QUALITY ASSURANCE -- NON-CONFORMANCE REPORT

Location: Changxing Island, Shanghai, PRC **Report No:** NCR-000485
Prime Contractor: American Bridge/Fluor Enterprises, a JV **Date:** 26-Nov-2009
Submitting Contractor: Zhenhua Port Machinery Company, Ltd (ZPMC), Changxing Island **NCR #:** ZPMC-0458

Reference Description: East Shaft, Lift 4, CD corner seam weld repair without Engineer approval

Reference Description: CWR - Weld Repair Performed Without Engineer's Approval / East Tower Lift 4, CD Corner Seam / Transverse Indication

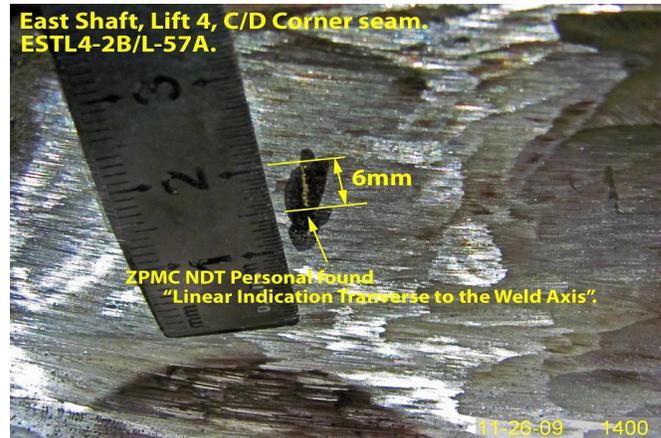
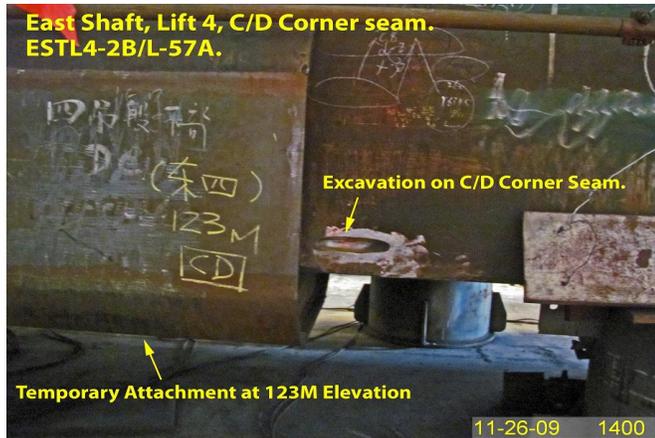
During in-process visual inspection of East Tower, Lift 4, CD corner seam weld repair excavation, QA observed a crack-like linear indication, transverse to the weld axis, approximate 6 mm in length. This excavation was for the repair of a rejectable indication found by ZPMC Ultrasonic Testing (UT) technicians. ZPMC NDT personnel performed Magnetic Particle Testing (MT) on the excavated area, confirmed the crack-like indication, and continued to perform Shielded Metal Arc Welding (SMAW) on the excavated area without prior approval of the Engineer.

Special Provisions, Section 8-3 Welding - "The Engineer shall be notified immediately in writing when welding problems, deficiencies, base metal repairs, or any other type of repairs not submitted in the WQCP are discovered and also of the proposed repair procedures to correct them. For requests to perform repairs, the Contractor shall include an engineering evaluation of the proposed repair. The engineering evaluation, at a minimum, shall include what is causing the defects, why the repairs will not degrade the material properties, and what steps are being taken to prevent similar defects from happening again in the future."

AWS D1.5-2002, Section 3.7.4 - "Prior approval of the Engineer shall be obtained for repairs to base metal, repair of major or delayed cracks, or for a revised design to compensate for deficiencies."

Reference Resolution: Currently this weld is under repair, when complete ZPMC will provide the CWR and NDT documentation to show the weld is acceptable. ZPMC requests that their proposal be accepted with actions pending.

Reference Resolution: ZPMC is providing the CWR used and NDT documentation which shows that the repair was successful.

Reference Description: East Shaft, Lift 4, CD corner seam weld repair without Engineer approval

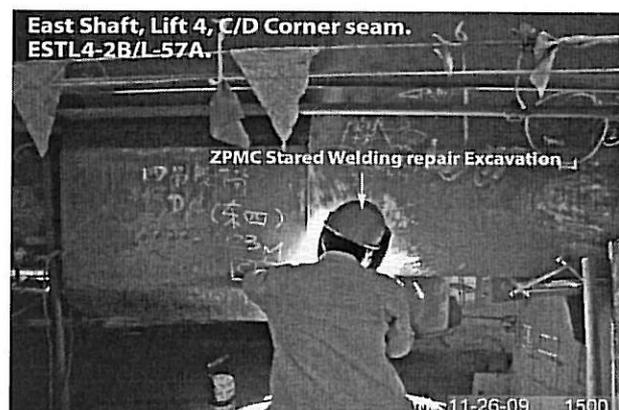
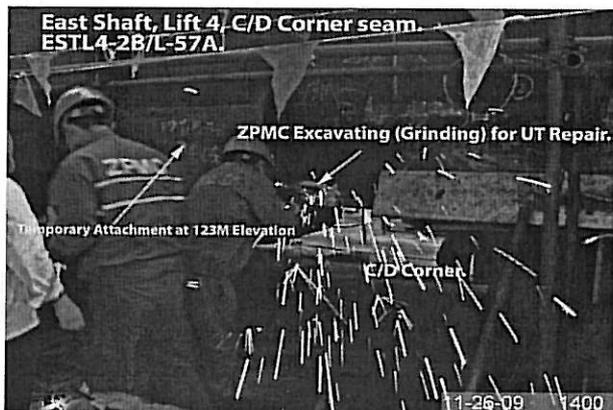
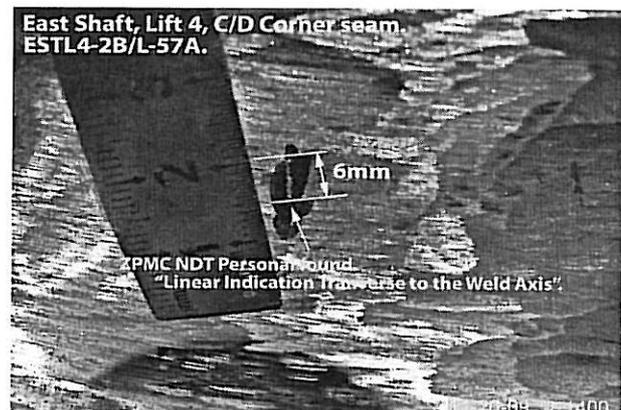
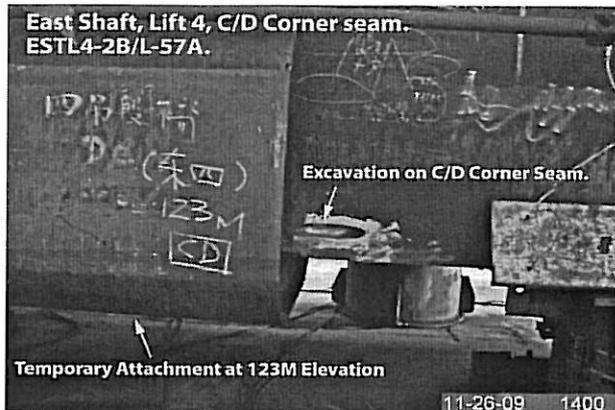
During in-process visual inspection of East Tower, Lift 4, CD corner seam weld repair excavation, QA observed a crack-like linear indication, transverse to the weld axis, approximate 6 mm in length. This excavation was for the repair of a rejectable indication found by ZPMC Ultrasonic Testing (UT) technicians. ZPMC NDT personnel performed Magnetic Particle Testing (MT) on the excavated area, confirmed the crack-like indication, and continued to perform Shielded Metal Arc Welding (SMAW) on the excavated area without prior approval of the Engineer.

Special Provisions, Section 8-3 Welding - "The Engineer shall be notified immediately in writing when welding problems, deficiencies, base metal repairs, or any other type of repairs not submitted in the WQCP are discovered and also of the proposed repair procedures to correct them. For requests to perform repairs, the Contractor shall include an engineering evaluation of the proposed repair. The engineering evaluation, at a minimum, shall include what is causing the defects, why the repairs will not degrade the material properties, and what steps are being taken to prevent similar defects from happening again in the future."

AWS D1.5-2002, Section 3.7.4 - "Prior approval of the Engineer shall be obtained for repairs to base metal, repair of major or delayed cracks, or for a revised design to compensate for deficiencies."

The weld repair was performed and verified by NDT. Documentation for this repair was provided (T-CWR-497 and T-787-UT-2432R4). This issue was discussed with the foreman to prevent reoccurrence.

(UT探伤返修第四次。) ESTL4-2B/L-57A/B

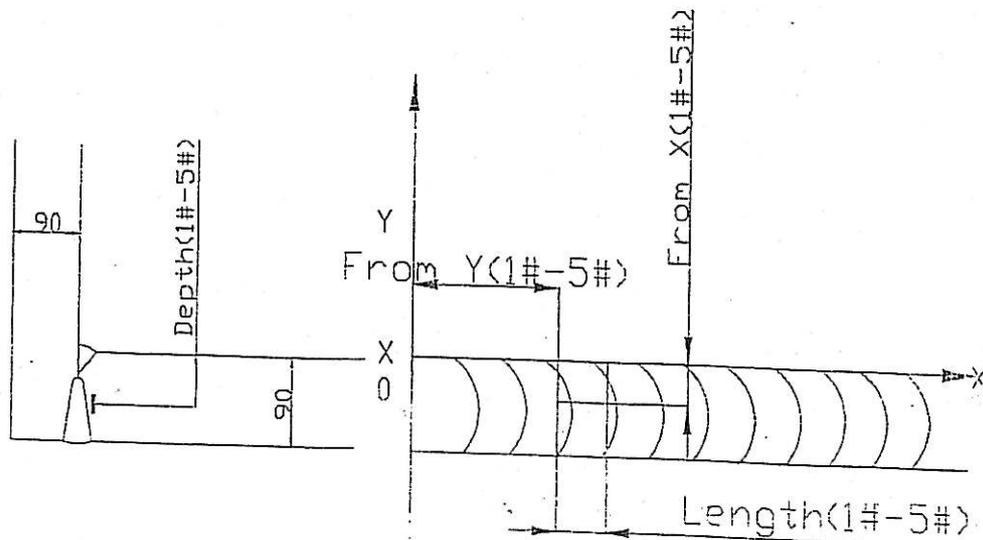
Rejected Indication found by ultrasonic inspection at fourth time.

1. The weld defect location may not have been properly identified prior to grinding, i.e, the X and Y location was incorrect or the excavation was not centered on the defect, therefore the excavation did not encompass the whole defect.

1. QC shall monitor and direct the welder and the grinder doing the repair operation.
2. Preheat before gouging; the temperature shall be at least 65°C.
3. Gouge the weld to remove identified defects.
4. Joint details shall refer to the approved WPS repair.
5. Grind the gouged areas to a smooth and shiny surface.
6. Verify with VT and MT to ensure no defects remain in the weld joint prior to welding.
7. QC shall monitor all welding passes being deposited.
8. QC shall ensure all slag has been removed prior the deposition of next pass.
9. Preheat and maintain interpass temperature control in accordance with the WPS.
10. Blend the weld repaired areas into the adjacent weld or base metal by grinding.
11. Perform VT, MT and UT NDT inspection to the repaired areas.
